Access Compliance Report Public Rights-of-Way (Pedestrian Signals)

Main Street: RED_HILL_AVE Cross Street: IRVINE_BLVD Location: SE

ADA ID: SGAT211027090022 Signal Type: One Push Button-APS Overall Compliance: No Severity Scores: BTN 1: 25 BTN 2: N/A No BTN: N/A

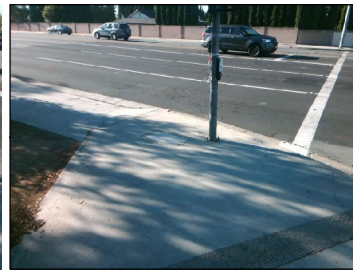
Possible Solutions: Remove and Replace Clear Space.

OC Std/PROW: R404.2
